SUBJECT OR TITLE: **DEVAGRMOD 2019-01 Durbin Creek National Development Agreement Modification (First Reading)**

Application for Development Agreement Modification
File Number: DEVAGRMOD 2019-01
Durbin Creek National

To:	Board of County Commissioners
From:	Phong T. Nguyen, Transportation Development Manager
Date:	February 21, 2020
Subject:	DEVAGRMOD 2019-01, request for modification of the Durbin Creek National Development Agreement for the Durbin Park PUD
Applicant:	Durbin Creek National, LLC
Representative:	Ellen Avery-Smith, Rogers Towers, P.A.
Hearing dates:	Board of County Commissioners – March 17, 2020 Board of County Commissioners – May 19, 2020
Commissioner District:	District 1

REVISED EXHIBIT 3

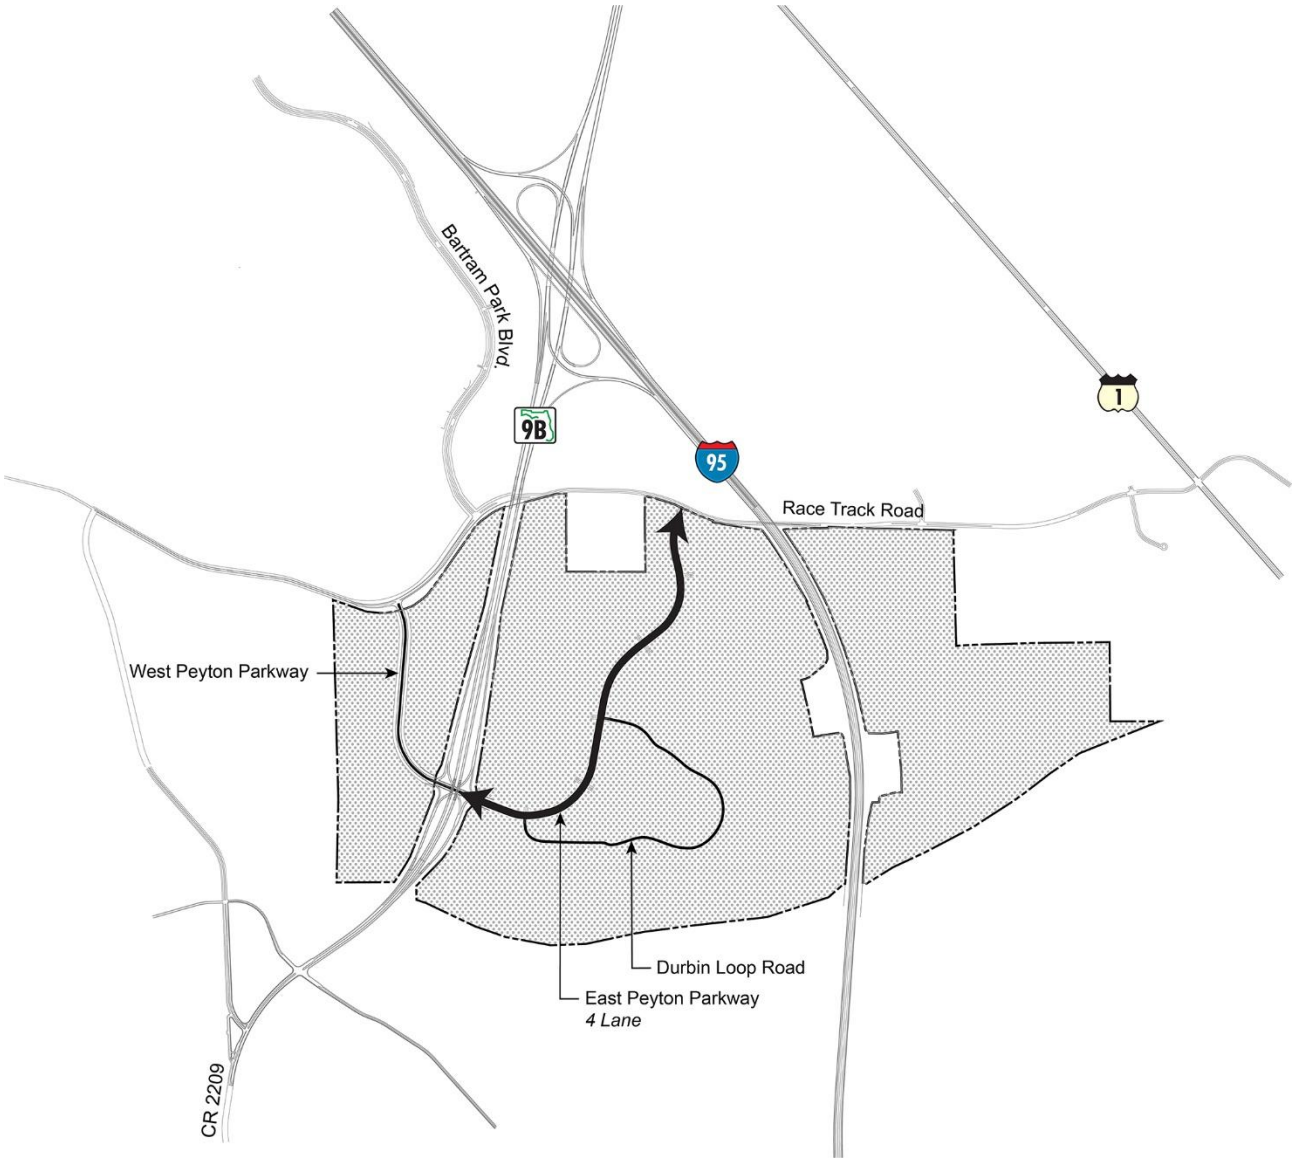
Estimated Cost: $19,638,844 (2019 Dollars)

REVISED EXHIBIT 4

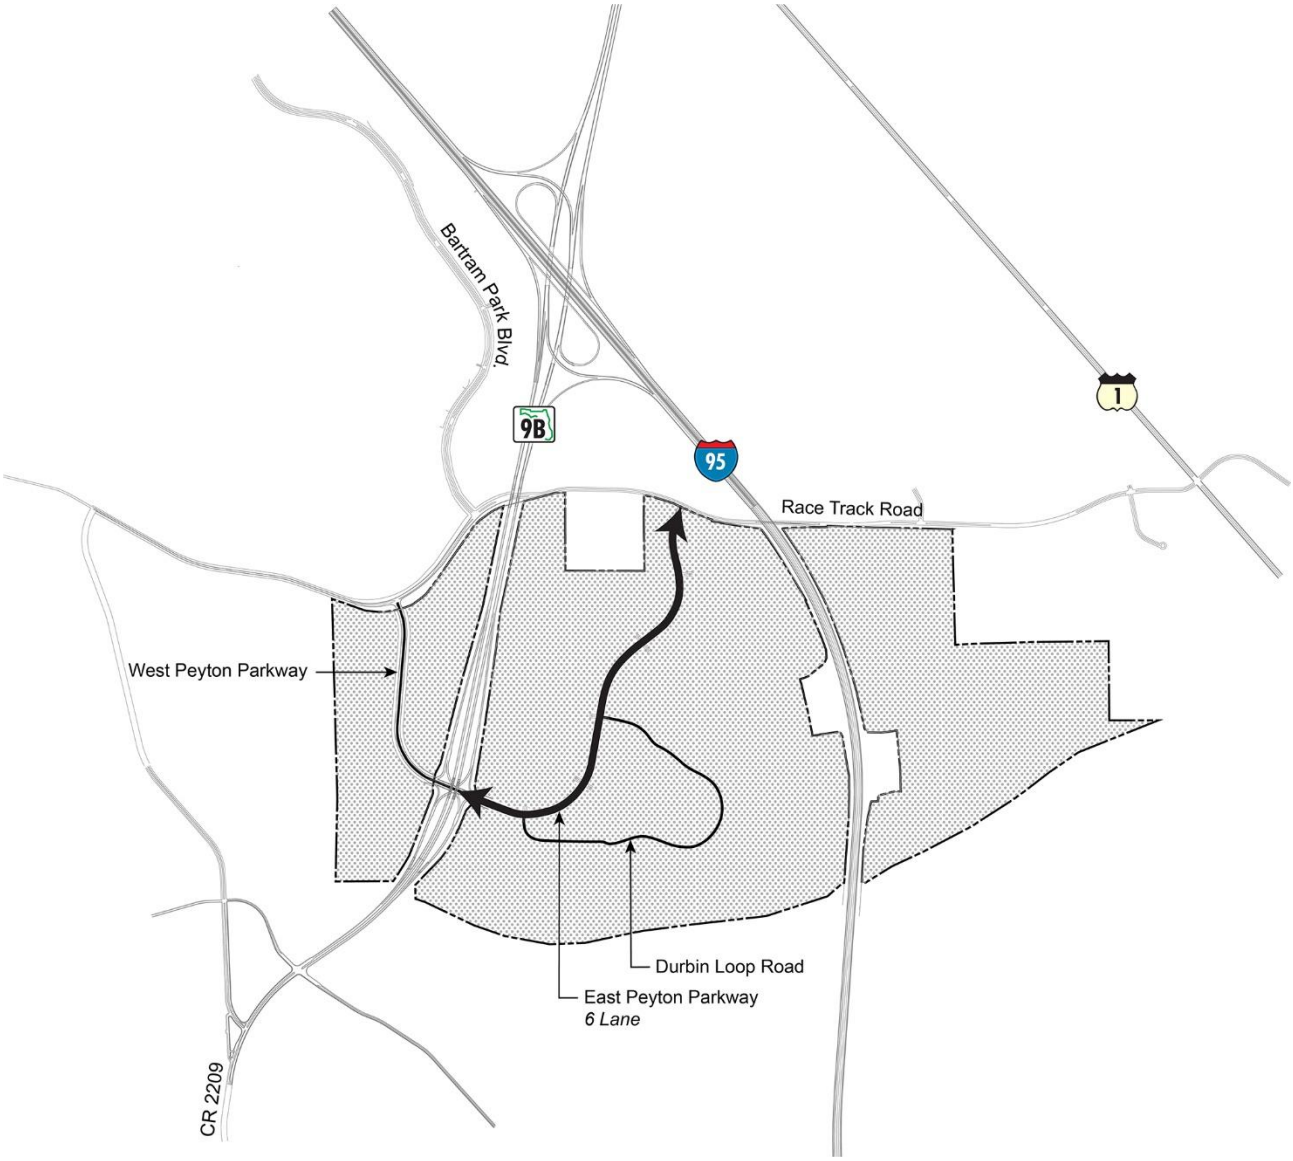
East Peyton Parkway 6-Lane Construction – Phase 3 Roadway Improvements

Estimated Cost: $2,720,311 (2019 Dollars)

Existing Phase 4

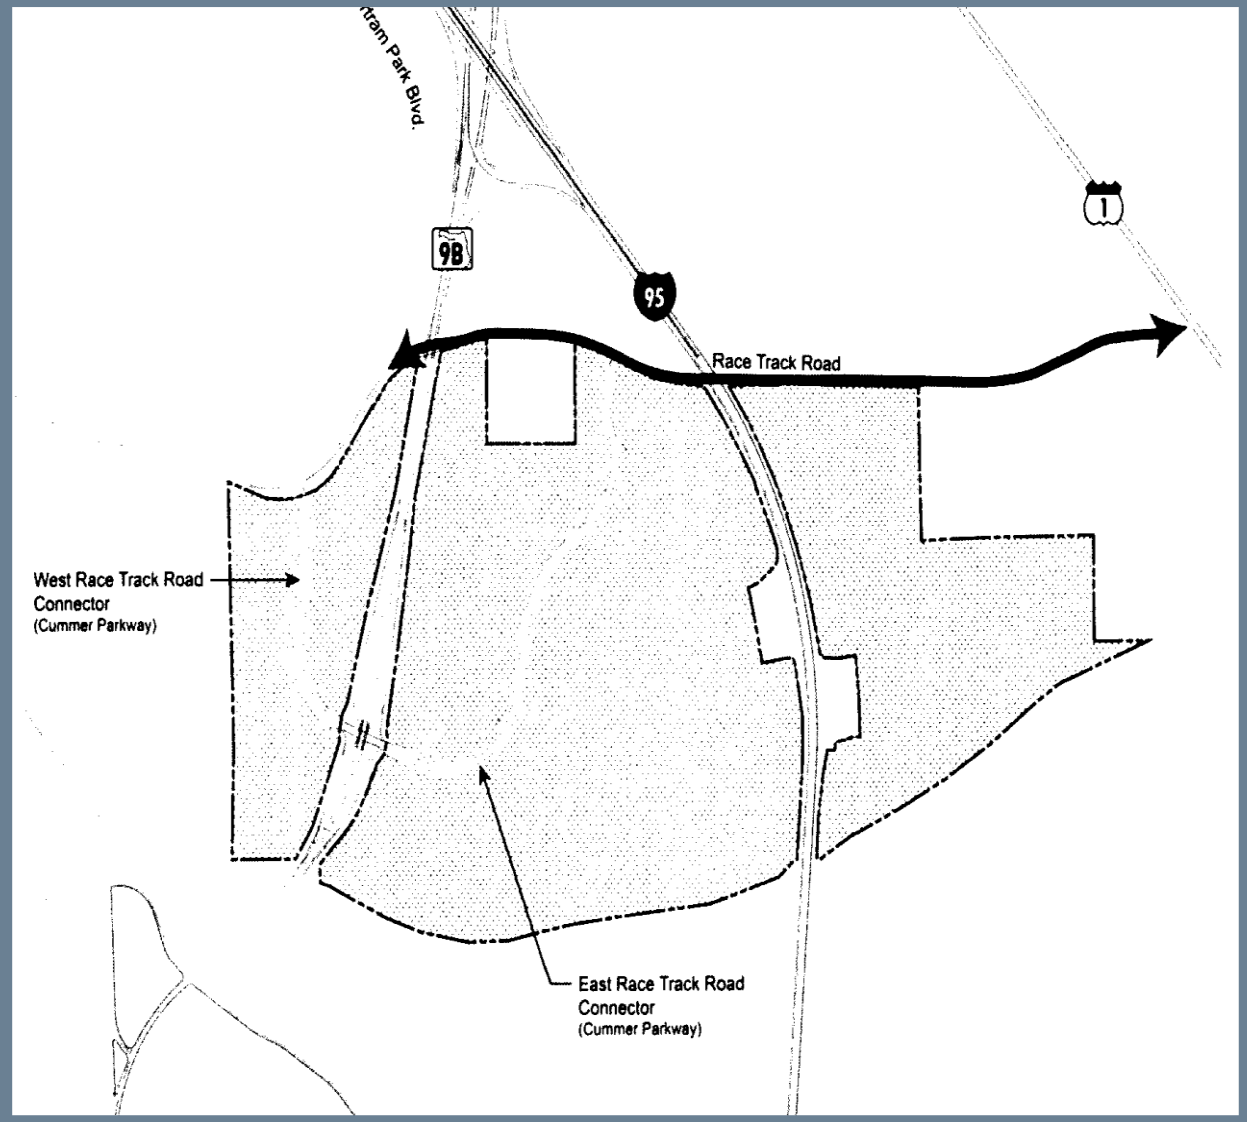
- 97,130 sq. ft. Shopping Center Space, 261,065 sq. ft. Office Park, 300 Apartment Units
- 683 PM peak net trips
- Improvement costs: $20,798,446 or $16,464,946 (Depending on FDOT)
- Roadway Improvements:
  - Design 6- lane and construct 4-lane of Race Trace Road from Bartram Park Boulevard to Bartram Springs Parkway
- Proposal to remove 6-laning of Race Track Road from agreement based on projection of improvement not being needed until buildout
- TIF funding will be available if widening is required at buildout
